ADDENDUM NO. 2

PROJECT NAME: SAFD Warehouse Fire Protection Systems

DATE: 9/13/13

CIMS PROJECT NO.: 20-01050

SHEET
M1.1R

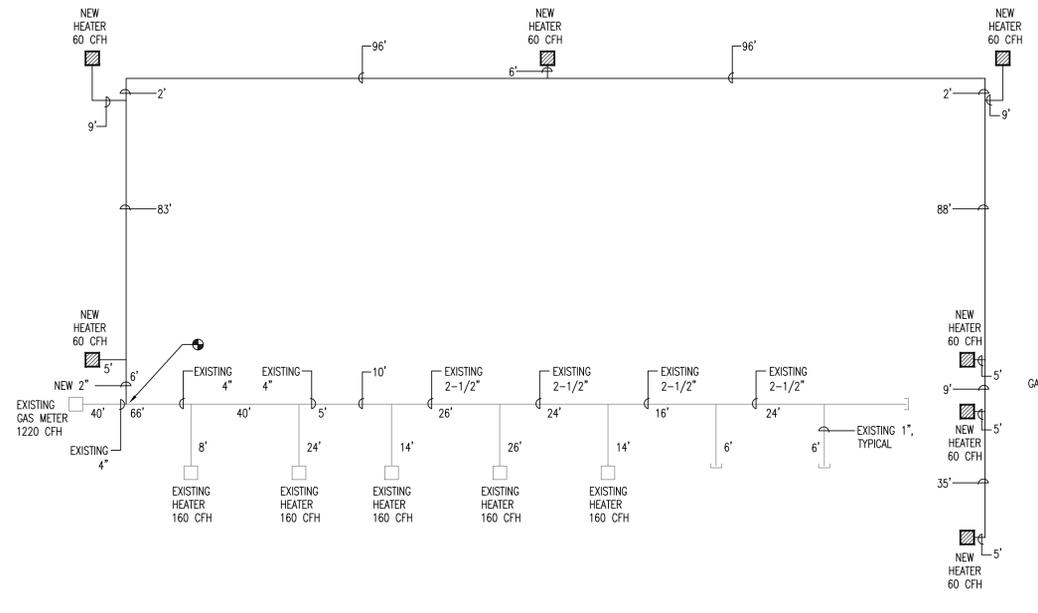
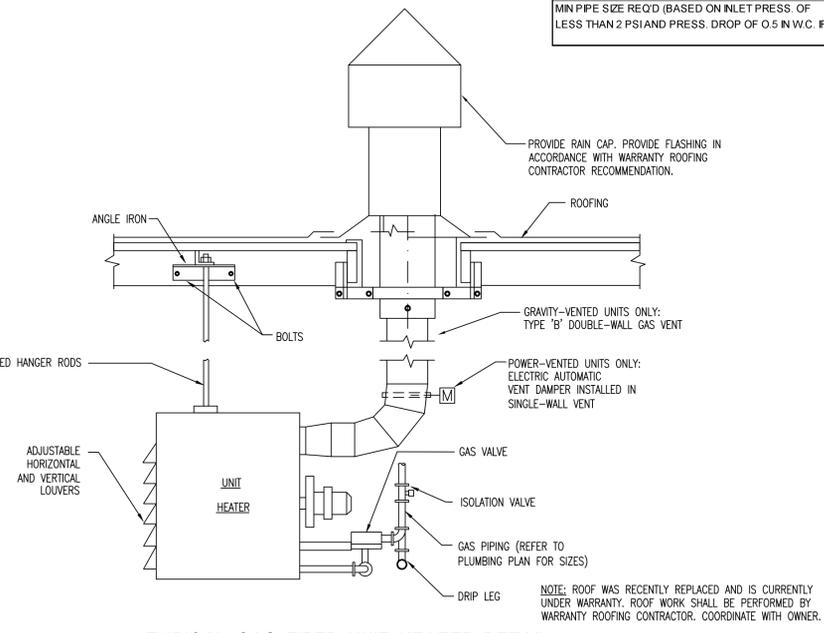
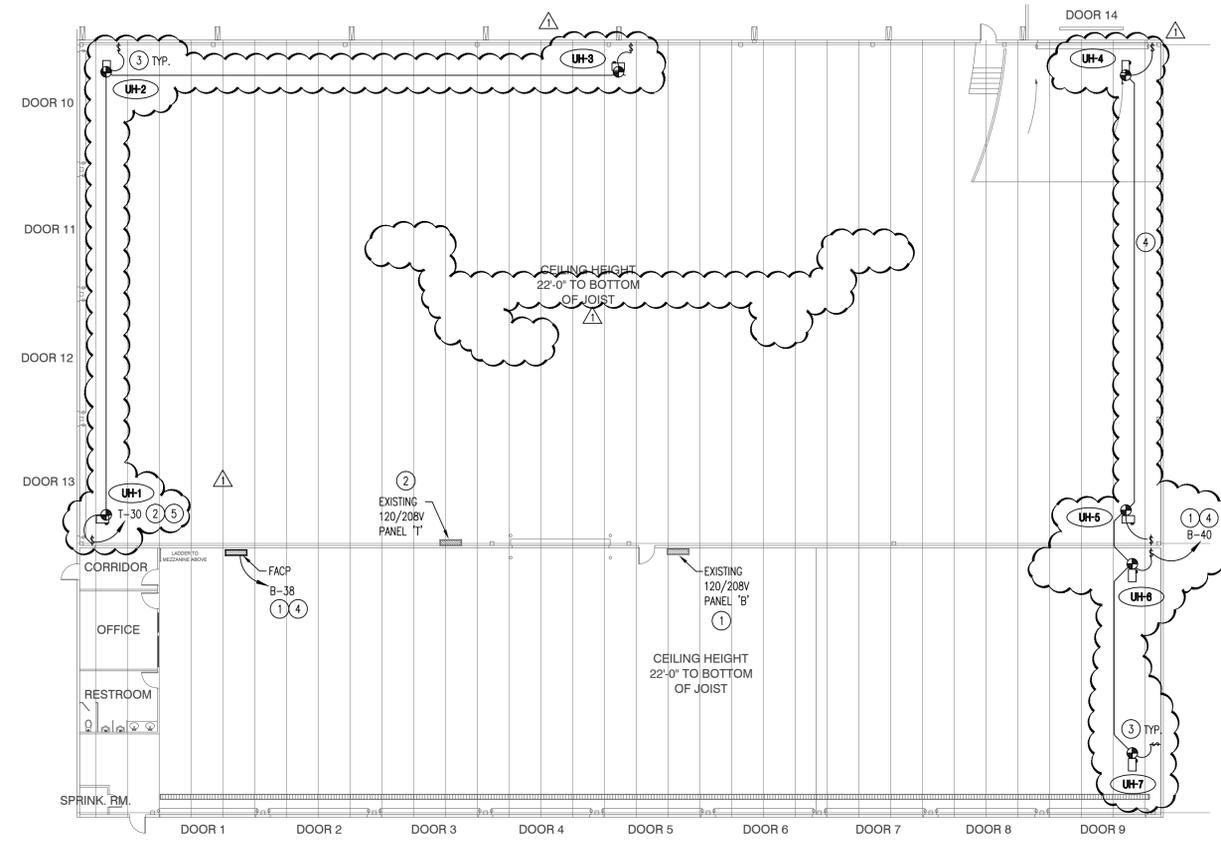
PLAN SHEET M1.1

- Delete this sheet in its entirety and replace with attached sheet M1.1R.
